Re: Blue Vista Subdivision, Town of The Blue Mountains
Revised Draft Plan

Re: Blue Vista Subdivision, Town of The Blue Mountains
Response to Comment for Draft Plan Application

We are in receipt of Town of The Blue Mountains Planning Review Committee Comments for the Blue Vista Application for Zoning By-Law Amendment and Draft Plan of Subdivision for Part Lot 17, Concession 1 in the Town of The Blue Mountains, Town file #P2737, dated June 11, 2019.

OVERALL WATER DISTRIBUTION
PLAN

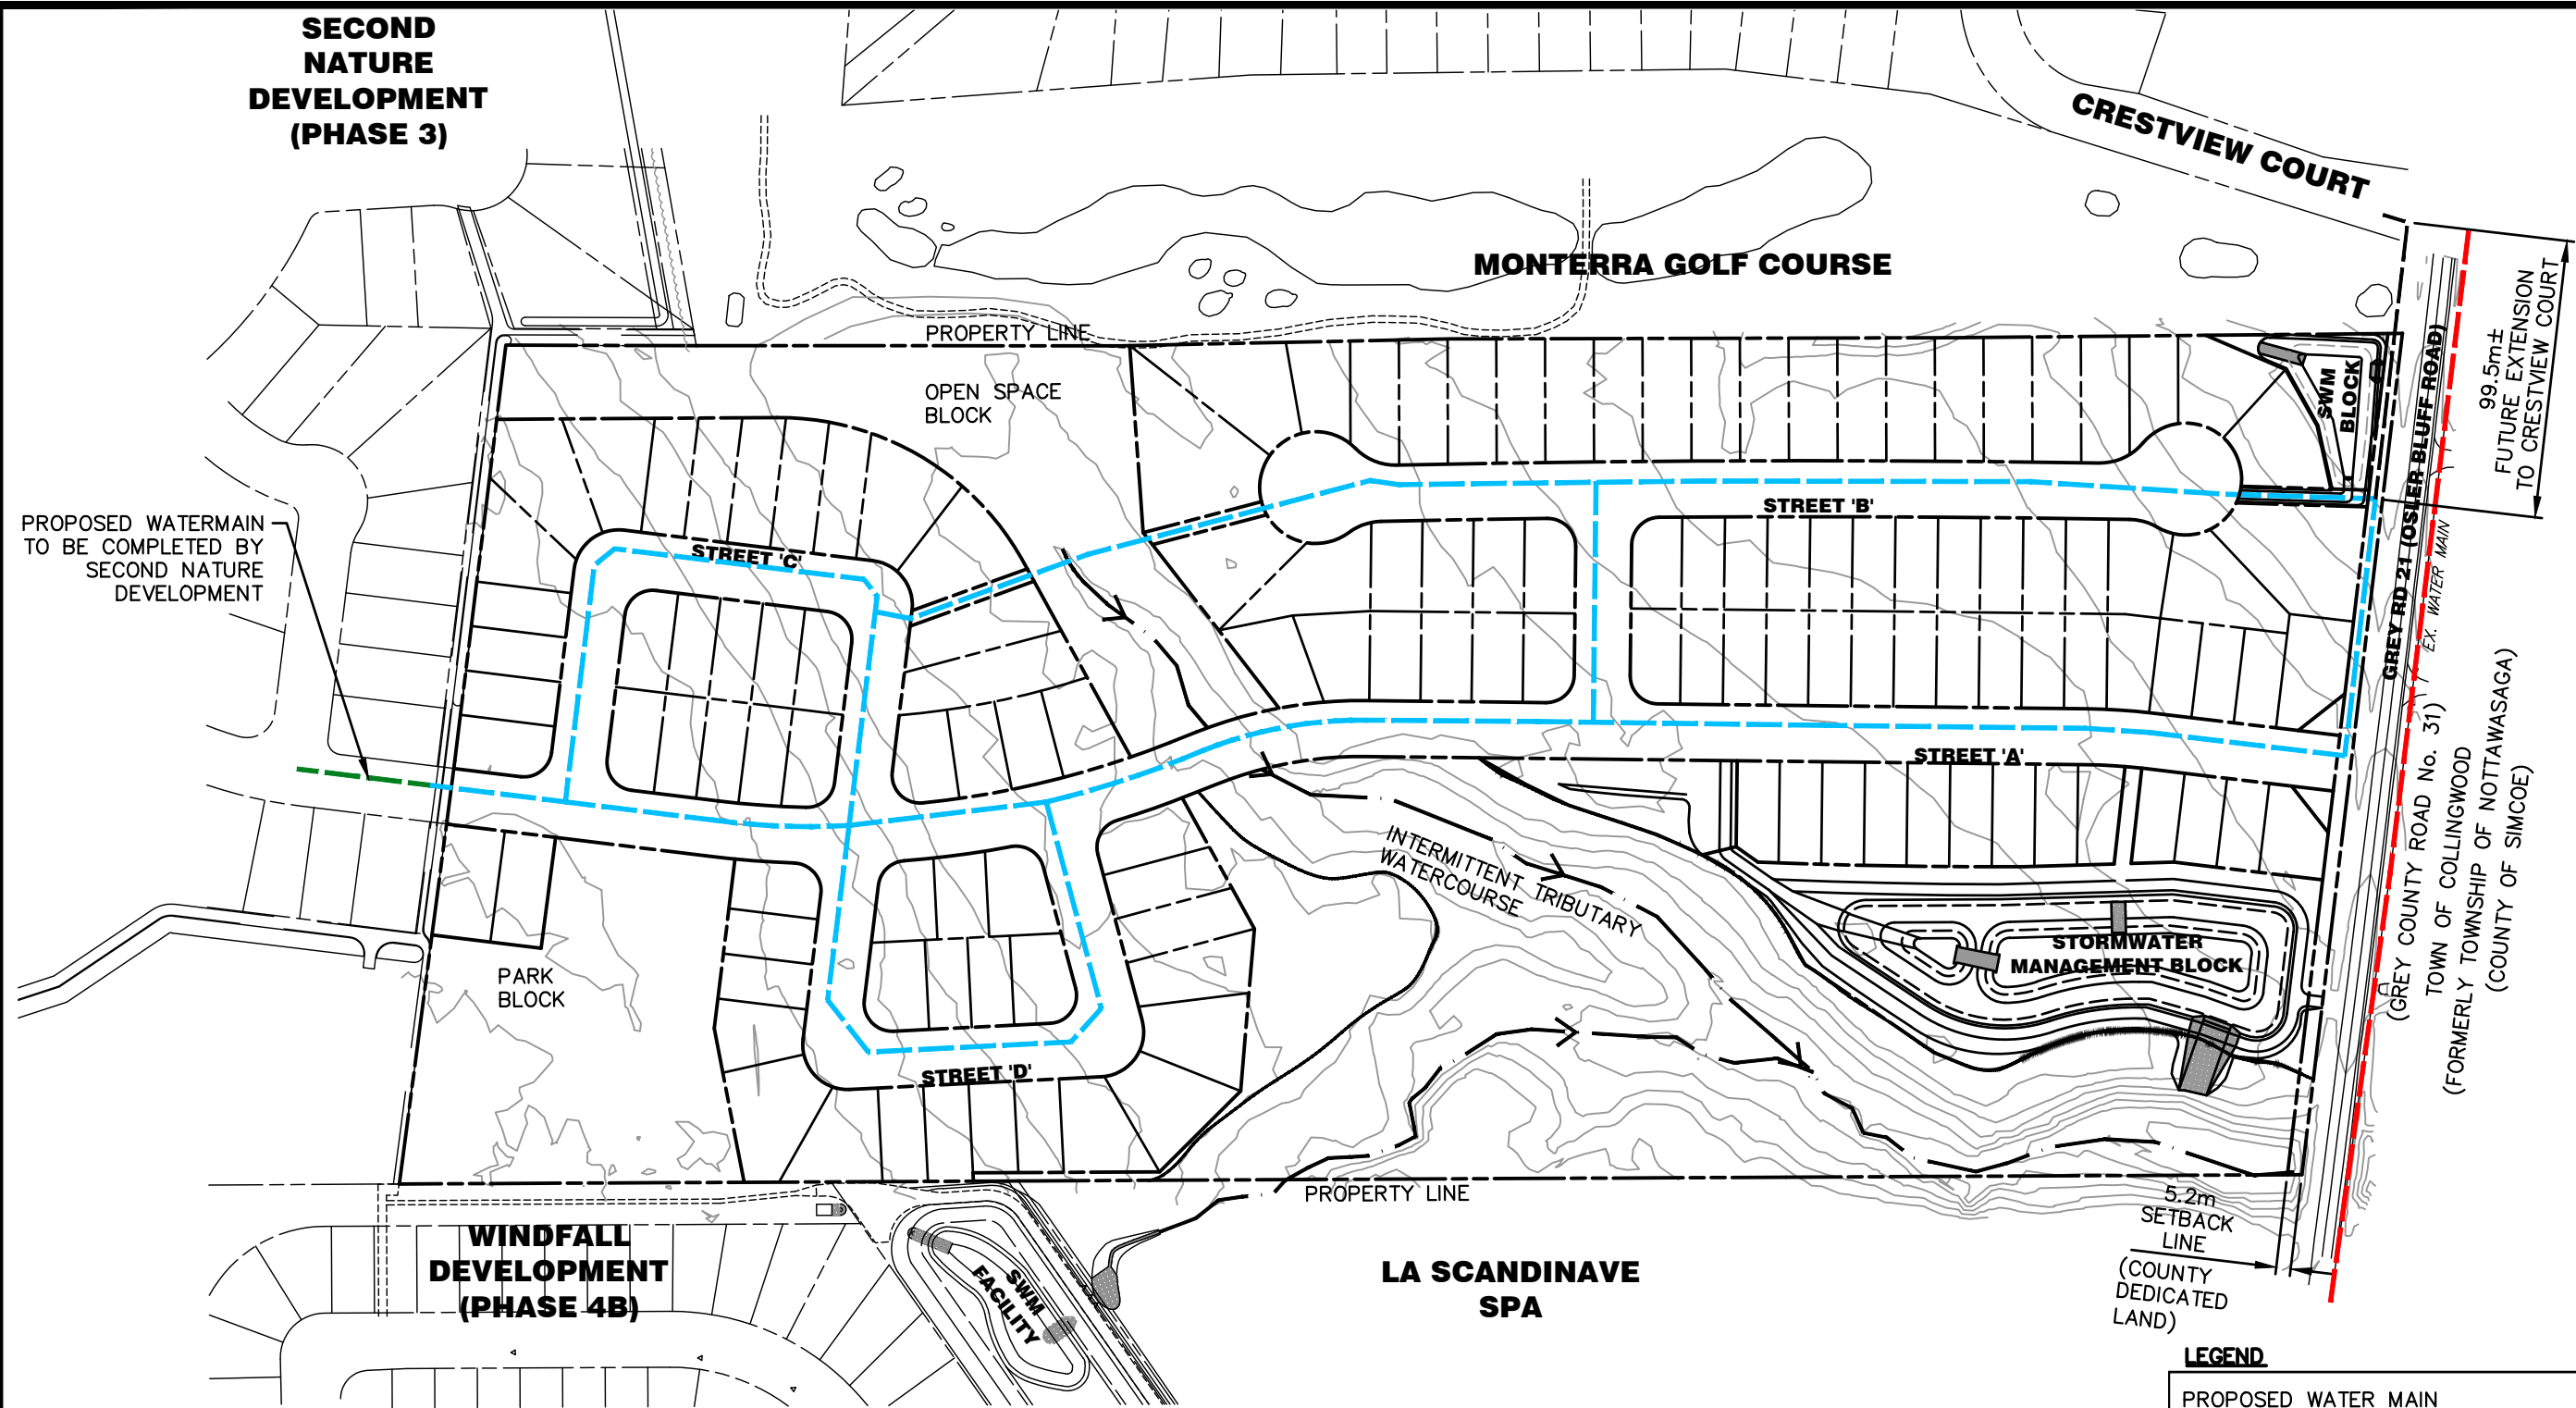
- c. The proposed watermain looping as illustrated on Figure 4 is not preferred. Consider the earlier comment regarding the re-design of Street 'B' to a crescent to provide better water looping ability.

- e. Provide the Town with Steady State Model developed to integrate with our model as described in Section 4.2 of the FSR. Please design the watermain system where a future connection can be made by the Town to the Plateau East (Crestview Court) subdivision at Grey Road 21.

- c. Looping of watermain on Street 'B' is not anticipated to provide any significant improvement to domestic pressures or flows available for firefighting. A watermain loop will provide some redundancy of supply should a watermain break occur along Street 'B' and may make it easier for the Town's operating staff to maintain. Re-designing Street 'B' is not warranted from a water servicing standpoint only. The watermain on Street B can be looped via Grey Road 21 to Street A and through Block 137 to Street D as illustrated on the enclosed Fig-4. (Note Block 139 would be shifted to the north side of Lot 66 to provide a more direct connection to Street D).

- e. A copy of the WaterCAD model used to analyze the Blue Vista water distribution system can be provided to the Town for their use on this file. A future watermain connection to the Crestview Court

subdivision at Grey Road 21 can be included. The future extension of the watermain along Grey Road 19 is illustrated on the enclosed Fig-4.

Design Chart 2.32: Inlet Control: Circular CSP and SPCSP Culverts

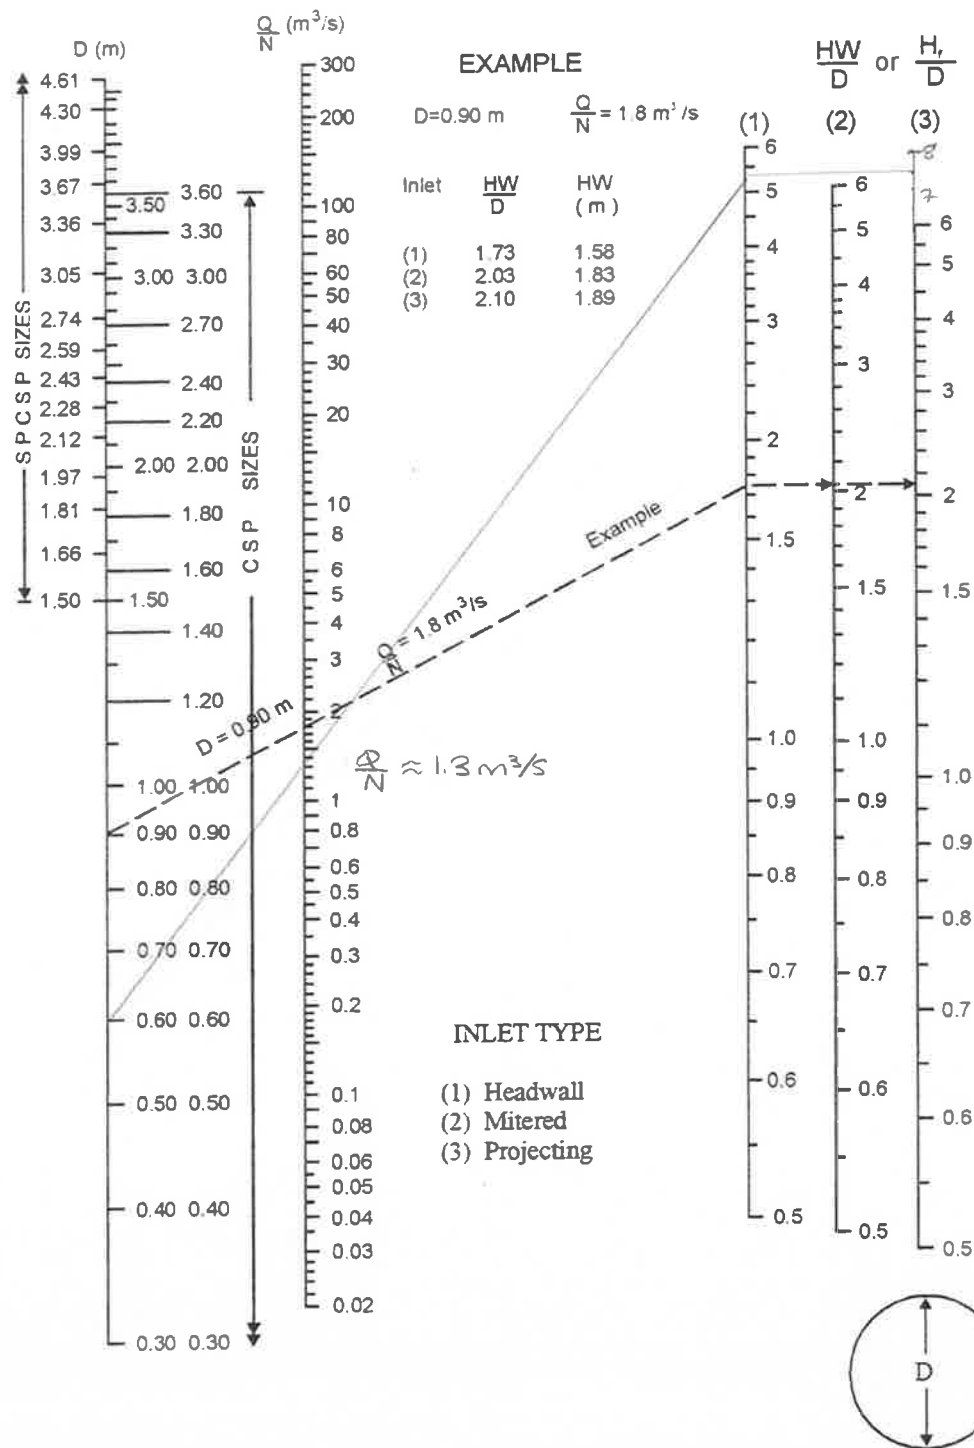
- f. Please provide the overall drainage area that flows through POI (Grey Road 21 600mm Culvert)
- g. Verify Culvert Capacity at Grey Road 21. (Using MTO Charts)

- g. The capacity of the existing 600 mm diameter CSP culvert under Grey Road 21 has been confirmed to be 1.1 m³/s through the MTO design charts (see enclosed).
